## Product/Process Change Notice (PCN)

**PCN Number:** PCN\_conDSUB\_20250101

**Affected Series:** WR-DSUB

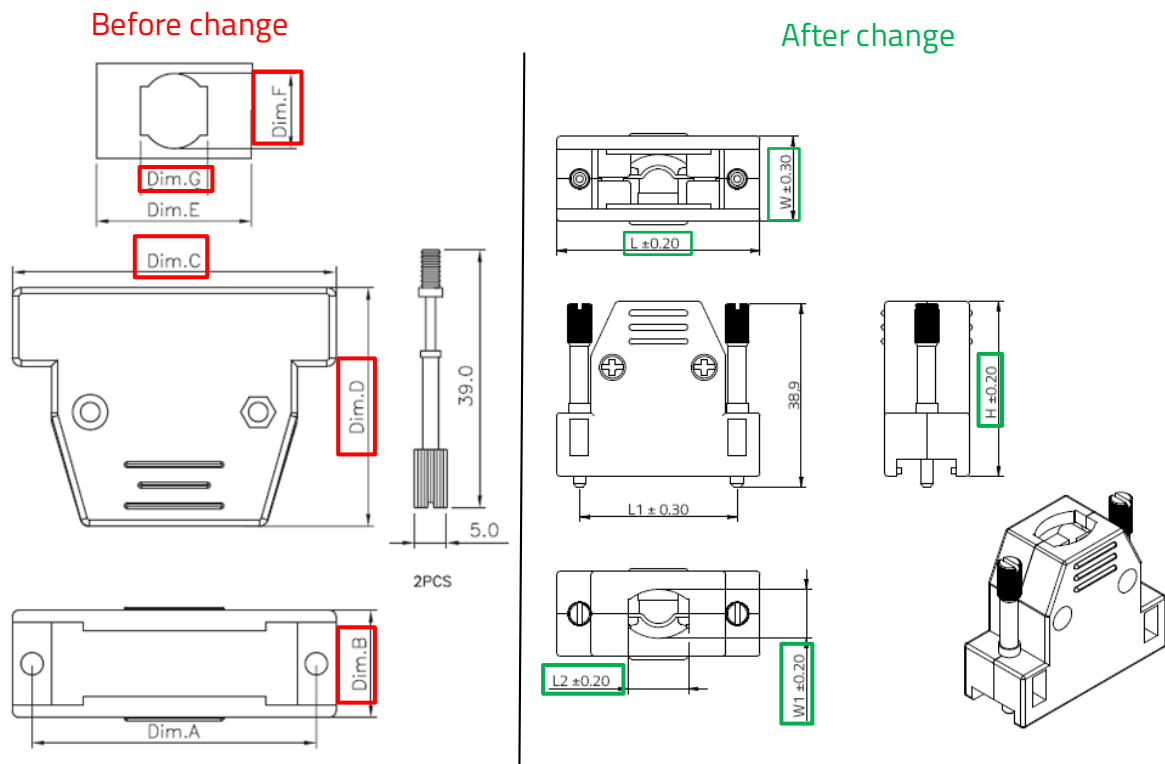
To increase the production capability, Würth Elektronik eiSos will change the production site of the above-mentioned products. This implies changes in design, tolerances, packaging dimensions and quantity. There will be no change in function, or reliability of the product. The new revision of the affected order codes will be sent out after the previous revision is out of stock (according to FIFO - first-in, first-out).

**2. Design Change**

Part number	B (mm)	C (mm)	D (mm)	F (mm)	G (mm)
61800925311	18.0	31.3	29.8	9.2	11.9
61801525311	18.0	43.2	37.1	10.4	12.8
61802525311	18.2	55.3	41.0	11.2	14.0
61803725311	18.2	70.5	48.0	14.0	15.8

Part number	W (mm)	L (mm)	H (mm)	W1 (mm)	L2 (mm)
61800925311	18.0	31.0	29.8	9.2	11.9
61801525311	18.0	43.2	37.1	10.4	12.8
61802525311	18.0	53.5	40.7	12.0	13.4
61803725311	18.0	70.5	46.7	14.0	16.0
